Access Compliance Report Public Rights-of-Way (Curb Ramps)

Intersection ID: 10037250	Main Street: SARDIS_HALL_CT	Cross Street: N/A	Location: E
ADA ID: 2D67287E2EC1	Ramp Type: Perp	Initial Pass/Fail: Fail	Overall Compliance: No Severity Score: 21.25
Codes/Mitigation Info/Possible Solution		Field Measurements/Component Compliance

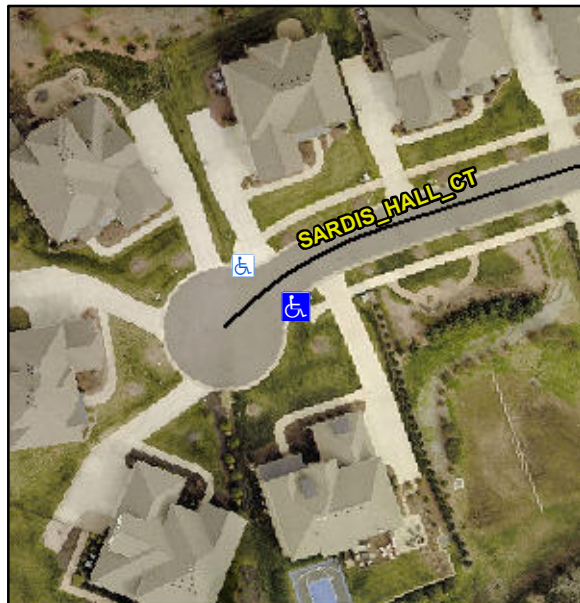
Possible Solutions:

Remove & Replace Entire Ramp.

PROW/ADA:

R304.5.1, R304.2.2
